MODERNIZATION AT CURRAN MIDDLE SCHOOL FOR:

MARK	DATE	DESCRIPTION
SD		
CD		
01.	08/23/07	ADDENDUM 1
02.	09/11/07	ADDENDUM 2
03.	11/01/07	ADDENDUM 3

FLOOR DEMO PLAN BUILDINGS D & E

A-122

A1 FLOOR/DEMO PLAN BUILDING 'E'

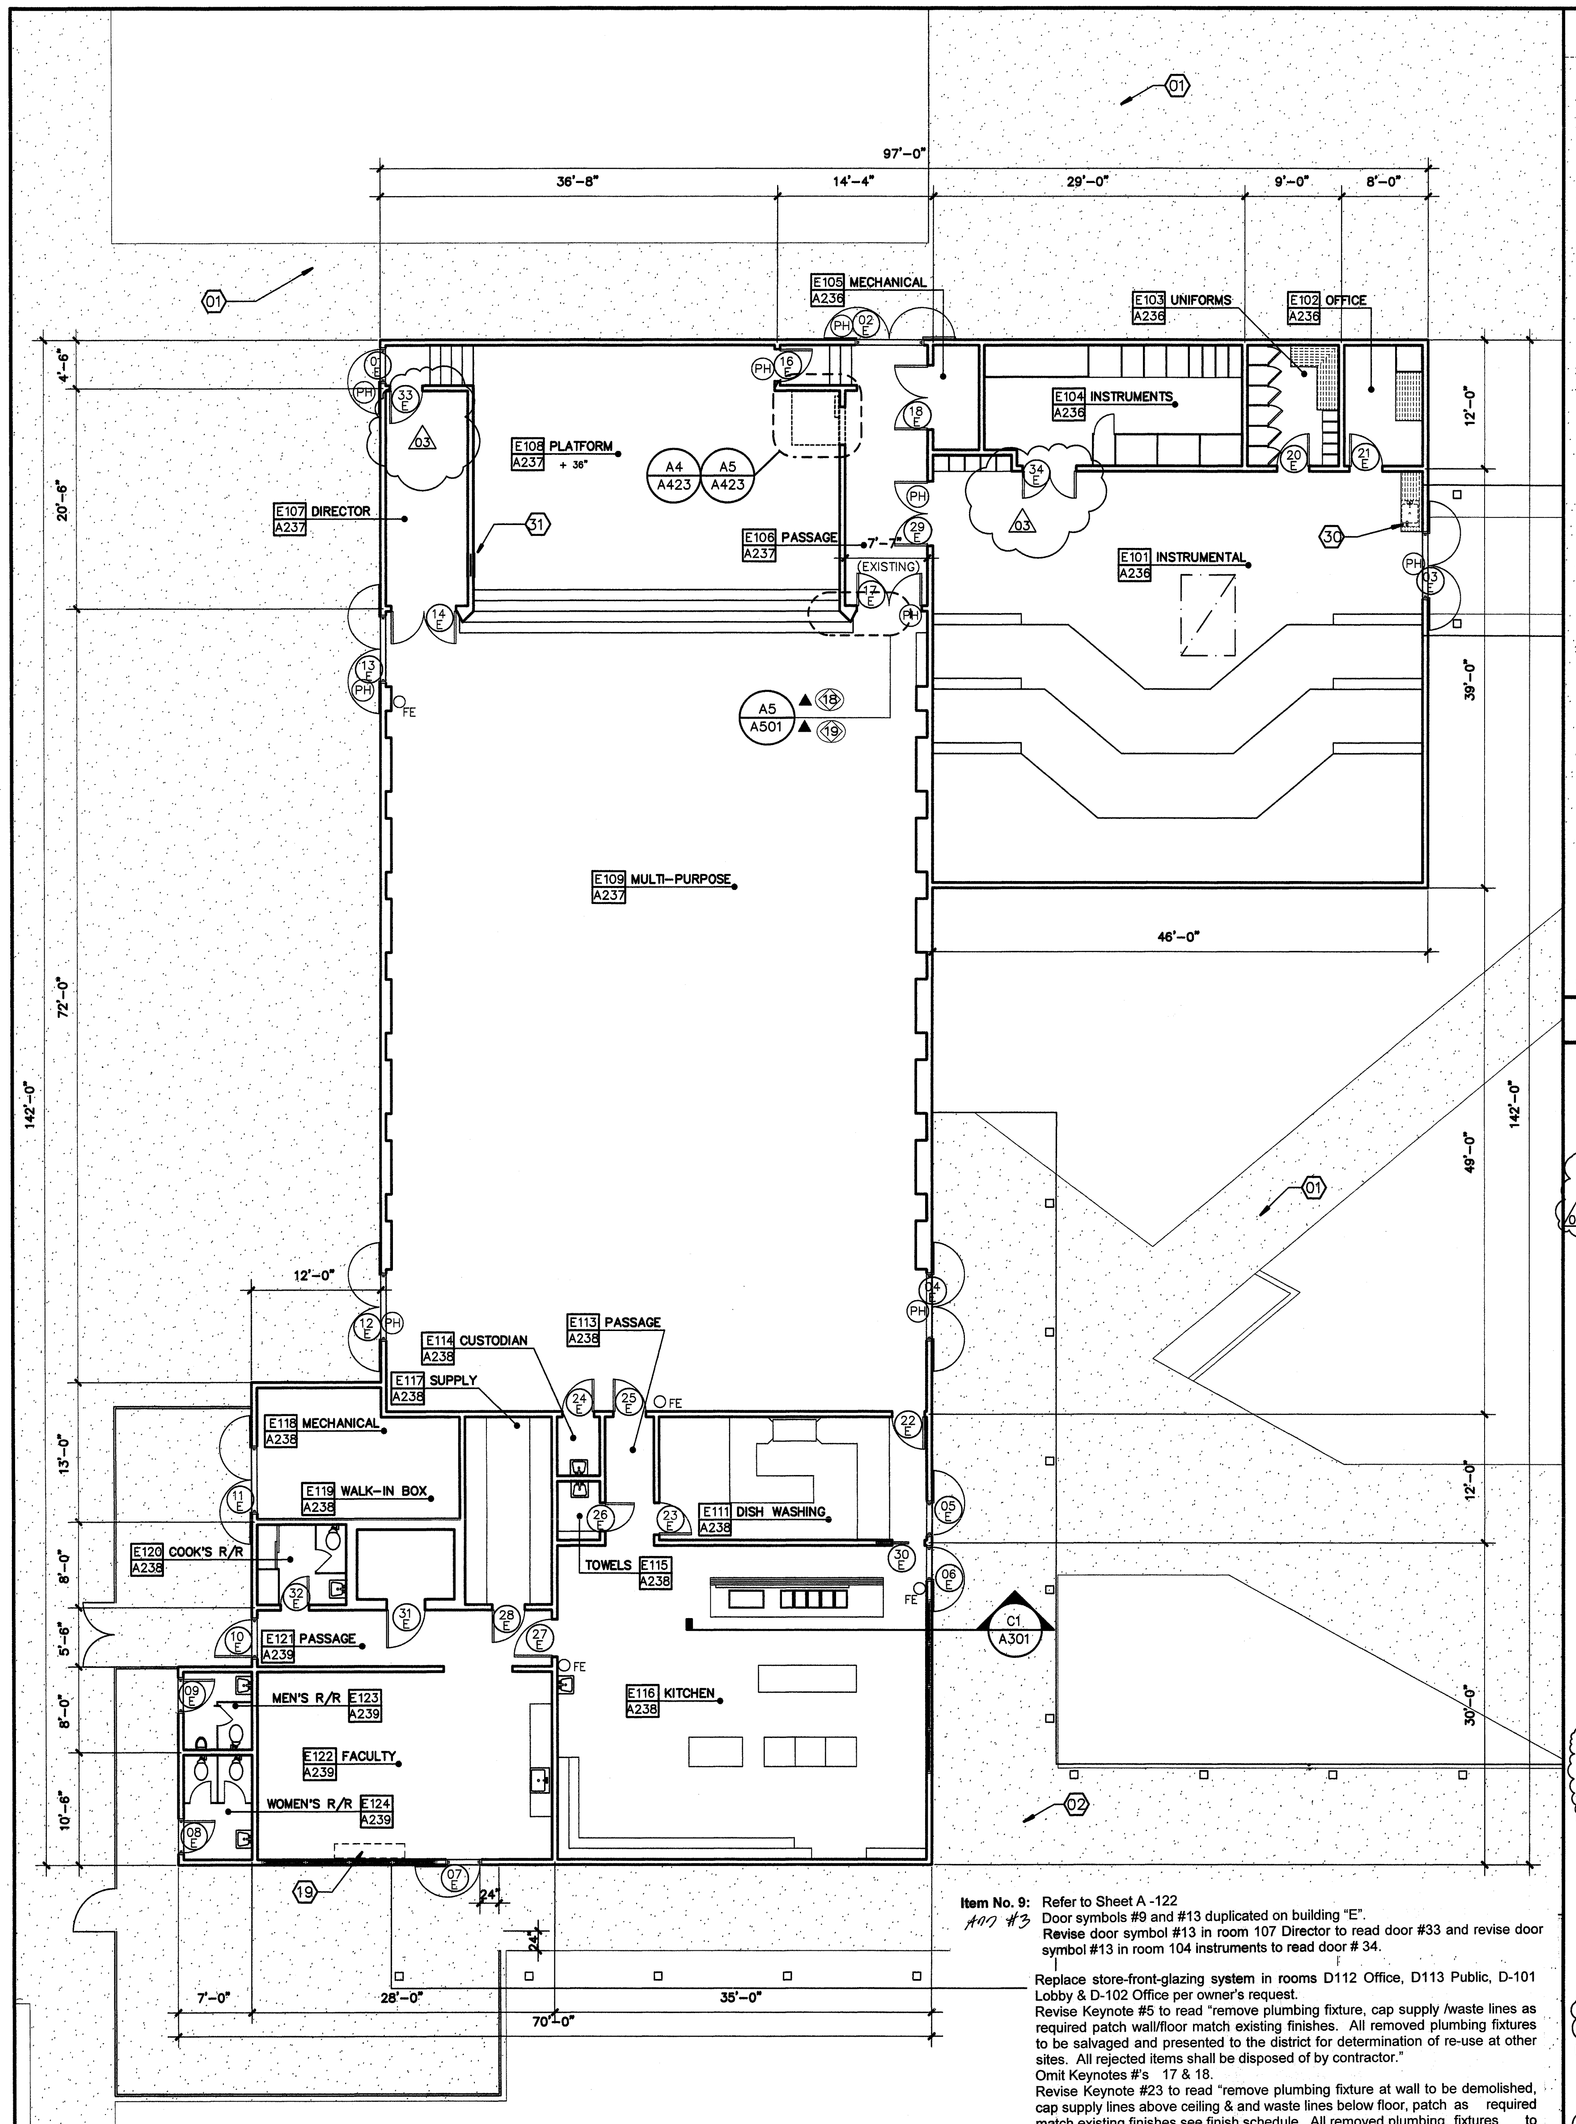
Item No. 9: Refer to Sheet A-122
Add #3
Door symbols #9 and #13 duplicated on building "E".
Revise door symbol #13 in room 107 Director to read door #33 and revise door symbol #13 in room 104 instruments to read door # 34.

Item No. 3: Refer to Sheet A-122
Add #7
Floor/Demo Plan Building "E" Office E-102; see Addendum Drawings ADD-020, ADD-021, & ADD-022 for additional conduit chase requirements. Demo Plan Building "E", see addendum drawing ADD-019 for additional conduit chase requirements; all concrete patching per Addendum Drawing ADD-010.

D4 DEMO PLAN BUILDING 'D'

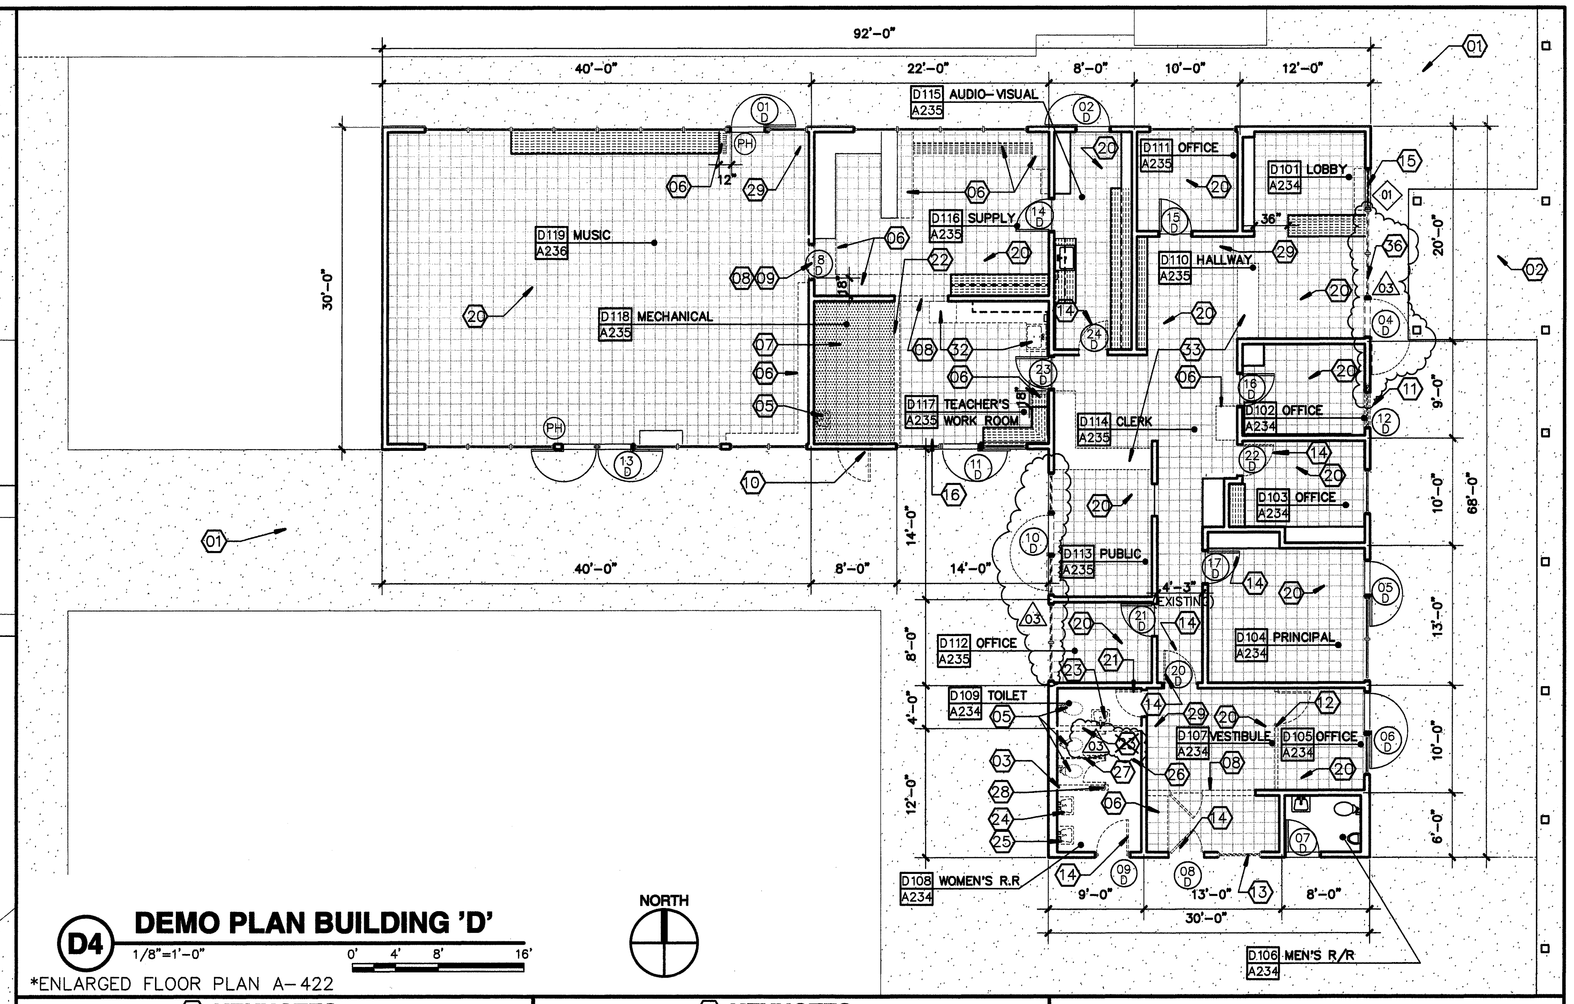
Replace store-front-glazing system in rooms D112 Office, D113 Public, D-101 Lobby & D-102 Office per owner's request.
Revise Keynote #5 to read "remove plumbing fixture, cap supply /waste lines as required patch wall/floor match existing finishes. All removed plumbing fixtures to be salvaged and presented to the district for determination of re-use at other sites. All rejected items shall be disposed of by contractor."
Omit Keynotes #'s 17 & 18.
Revise Keynote #23 to read "remove plumbing fixture at wall to be demolished, cap supply lines above ceiling & and waste lines below floor, patch as required match existing finishes see finish schedule. All removed plumbing fixtures to be salvaged and presented to the district for determination of re-use at other sites. All rejected items shall be disposed of by contractor."
Revise Keynote #24 to read "Remove plumbing fixture to provide accessible space. Cap supply and waste lines in wall and below floor patch surfaces as required match (E) finishes see finish schedule. All removed plumbing fixtures to be salvaged and presented to the district for determination of re-use at other sites. All rejected items shall be disposed of by contractor."

Revise Keynote # 25 to read "remove existing plumbing fixture, provide/install accessible fixture see plumbing drawings. Patch as required match existing finishes see finish schedule. All removed plumbing fixtures to be salvaged and presented to the District for determination of re-use at other sites. All rejected items shall be disposed of by contractor."
Revise Keynote #30 to read "remove sink cabinet to provide accessible sink cabinet. Remove and replace existing counter top, remove and replace sink see plumbing plans."
Revise Keynote #36 to read "demo existing store-front glazing system."
